Reduced Night Noise (RNN) Trial

Airline Survey Feedback

Date: 01 May 2019

Annex 2: Example IFP Designs

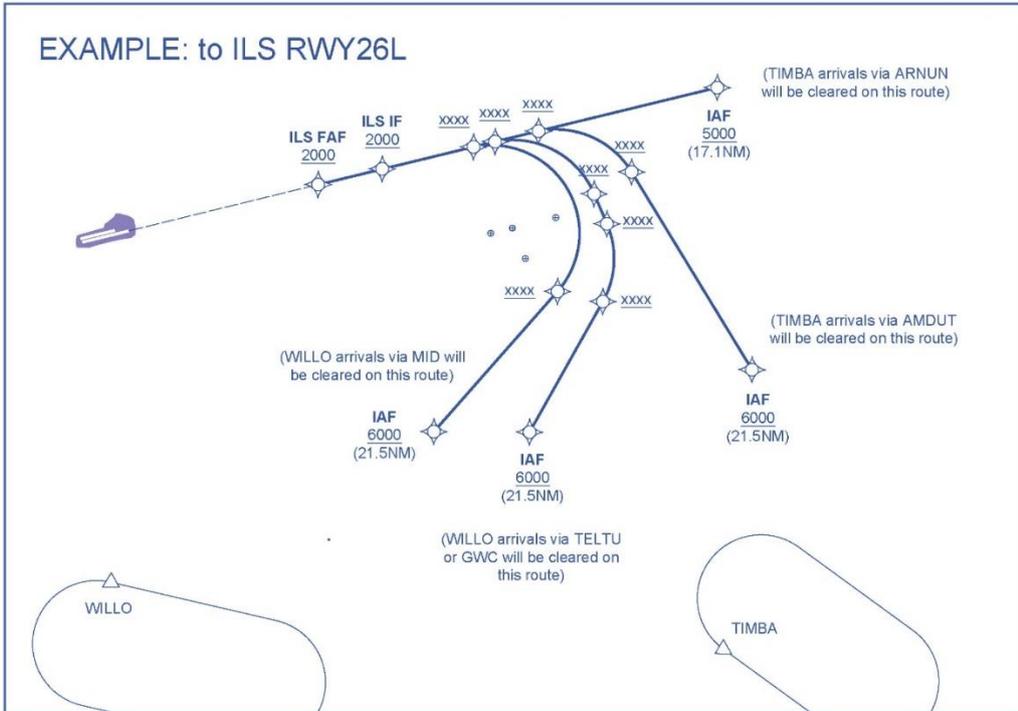
Airline	Comment
Virgin Atlantic Navigation Service	This would need to be checked for both the B747-400 and the A330 aircraft types. However, we believe this will be acceptable at least for the A330 fleet.
TUI Airways	Yes, dependant on any speed requirements.
British Airways	The level segment prior to the ILS will probably necessitate some application of power but should still be capable of relatively minimal drag...overall, this should still qualify as low noise.

Airline	Comment
Virgin Atlantic Navigation Service	No more than current operational considerations dictate.
British Airways	The use of the RNAV approaches to the Northern Runway are usually flown with a level segment before the (current) IAF. As long as this is still available then I see no issue. I do not think that we would be able to fly an RNAV procedure that started from the proposed (new) IAFs as we would then have to fly RF legs on the final approach segment, which I do not believe we can do at this time.

Subject	Description
RF Leg capability	Some operators have aircraft capable of RF legs but do not have operational readiness 3-4 months is required for individual airlines to achieve the required status.
Procedure design	Transitions are connected from IAFs to the existing FAF, however there is a disconnect between the end of the STAR and the start of the transition.
Procedure design	The procedures designs will include not below 3000ft and 6000ft altitude restrictions.
Procedure design	The procedure designs will include maximum speeds only. ATC will instruct crews of any other speeds required for sequencing, safety and to minimise noise where possible.
Procedure operation	ATC must provide a clearance as early as possible to aid continuous descent management. An instruction will be developed identifying a minimum distance from touchdown by which the crew should receive clearance.
IFP Validation	The 16 procedures should be validated on two aircraft types with different FMS (Airbus and Boeing), in a range of met conditions.
